Amendments to the Drawings:

Included in the amendment and attached are an "Annotated Sheet Showing Changes" and a "Replacement Sheet" for Figs. 2I, 2J, 2L, 2M, 2N, 2O, and 2R.

SERIAL NO.: 09/997,133
PETER H. PRIEST (919-942-1434)

FIG. 2N

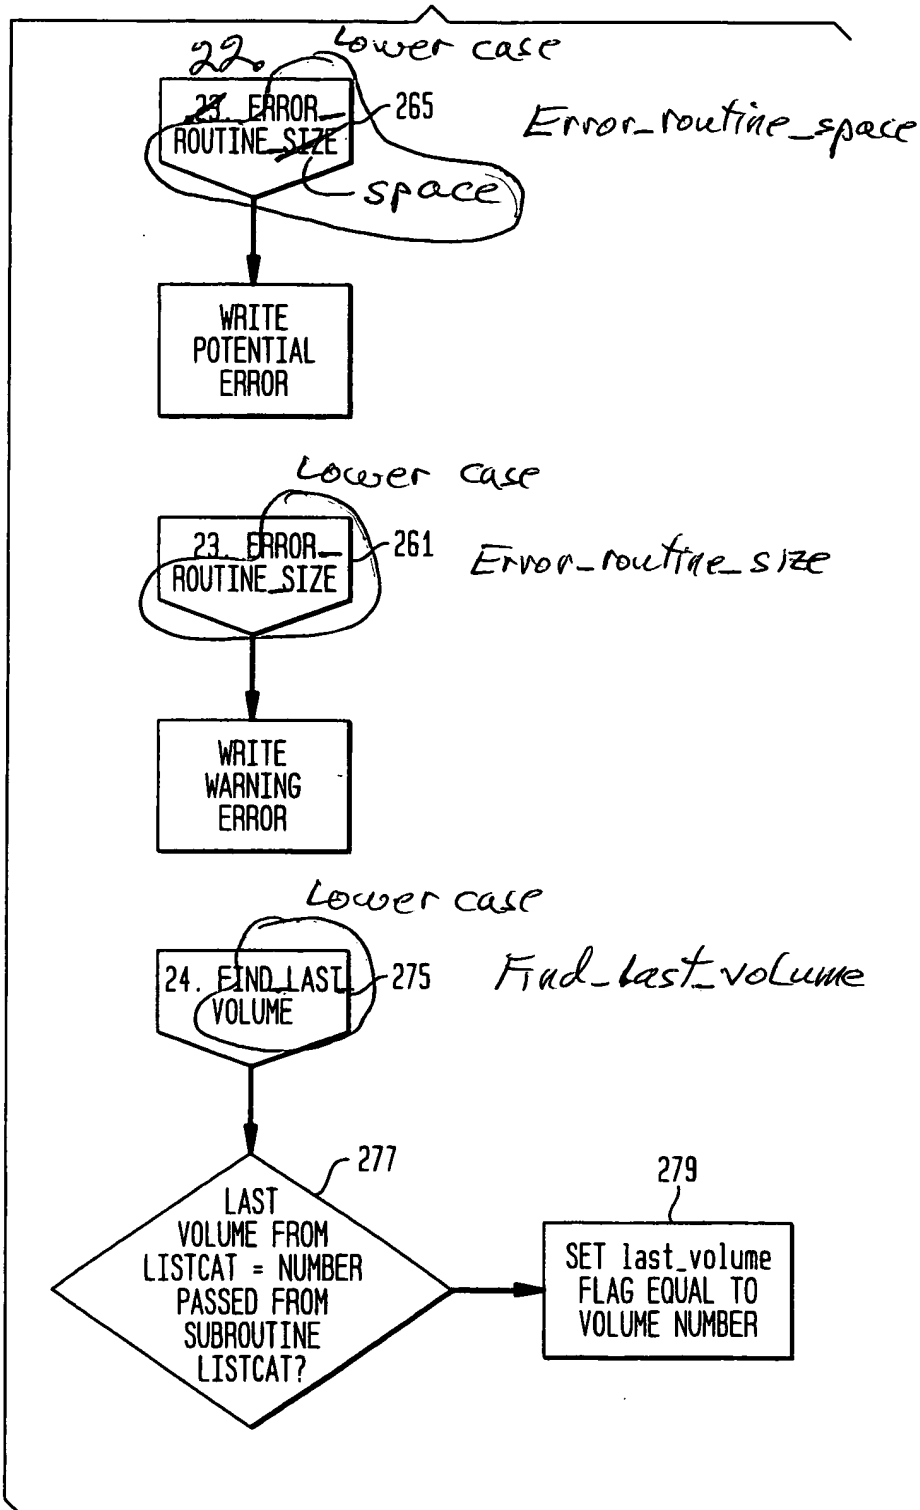
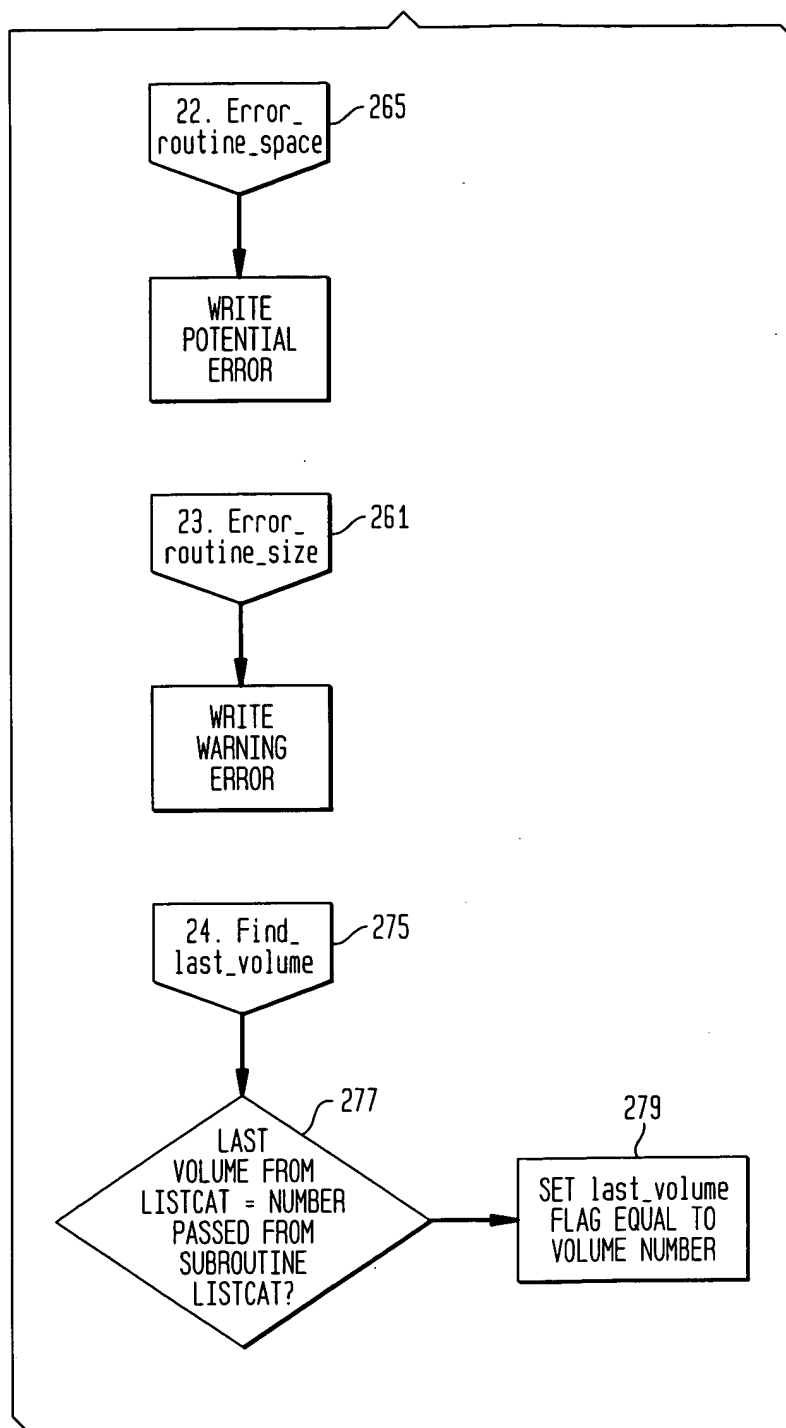
In Fig. 2N, the legend "23. ERROR ROUTINE SIZE" on block 265 is corrected to "22. Error_routine_space" to correct a duplicate number in the legends of blocks 265 and 261, an incorrect name, and be consistent with the capitalization and name reference used in the specification, for example, error_routine_space step 265 page 13, lines 7-8, and drawing Fig. 2M 22. Error_routine_space block 265. The legend "23. ERROR ROUTINE SIZE" on block 261 is corrected to "23. Error_routine_size" to be consistent with the capitalization and name reference used in the specification and other drawings. Also, the legend "FIND LAST VOLUME" on block 275 is corrected to "24. Find_last_volume" to be consistent with the capitalization and name reference used in the specification.

FIG. 20

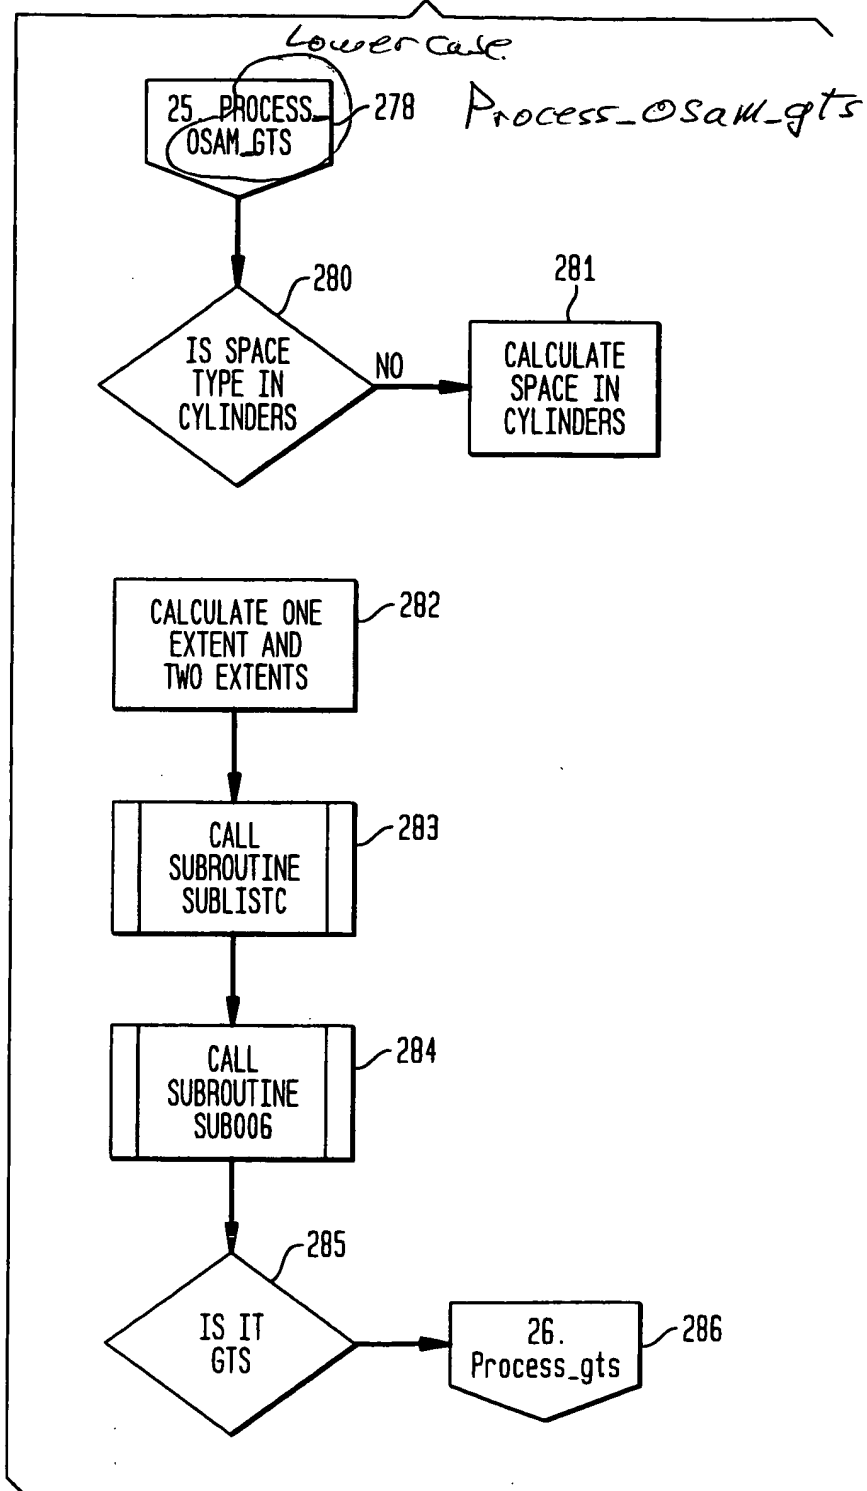
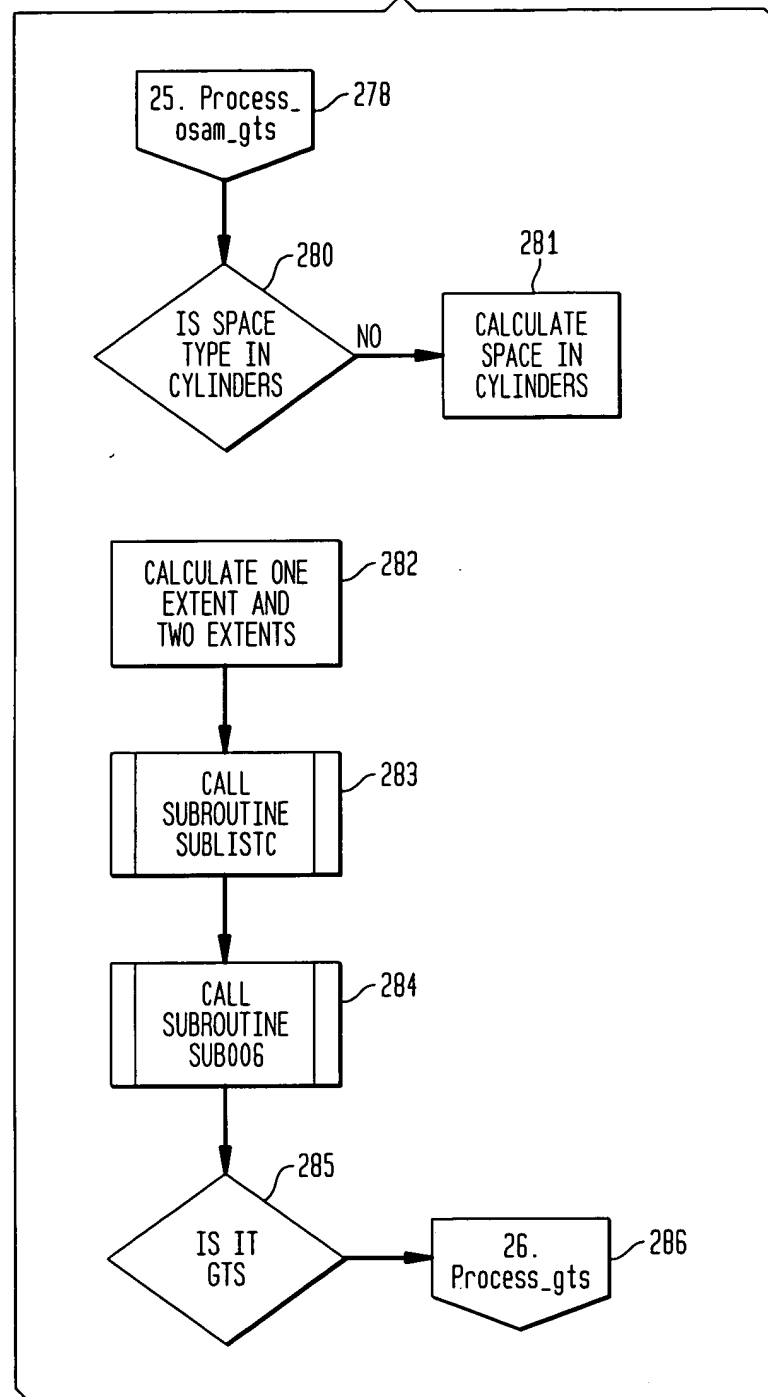
In Fig. 2O, the legend "25. PROCESS OSAM GTS" on block 278 is corrected to "25. Process_osam_gts" to be consistent with the capitalization and name reference used in the specification.

FIG. 2R

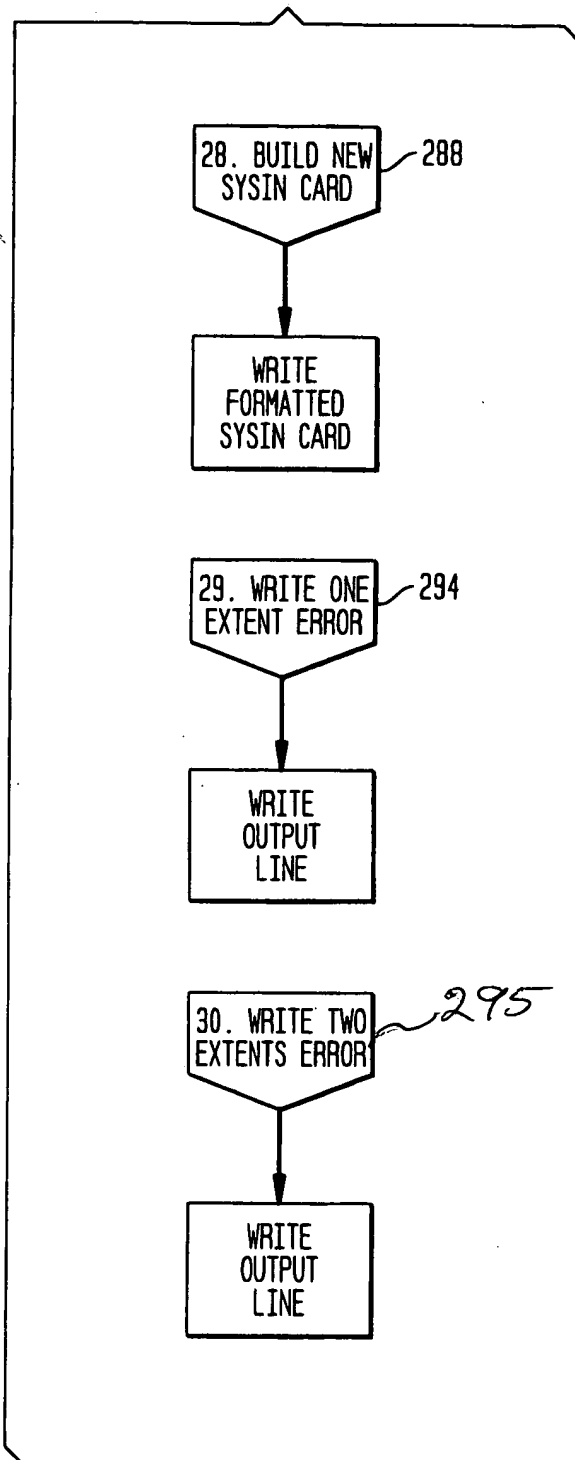
In Fig. 2R, the block with legend "30. WRITE TWO EXTENTS ERROR" is corrected to add the missing reference number 295.
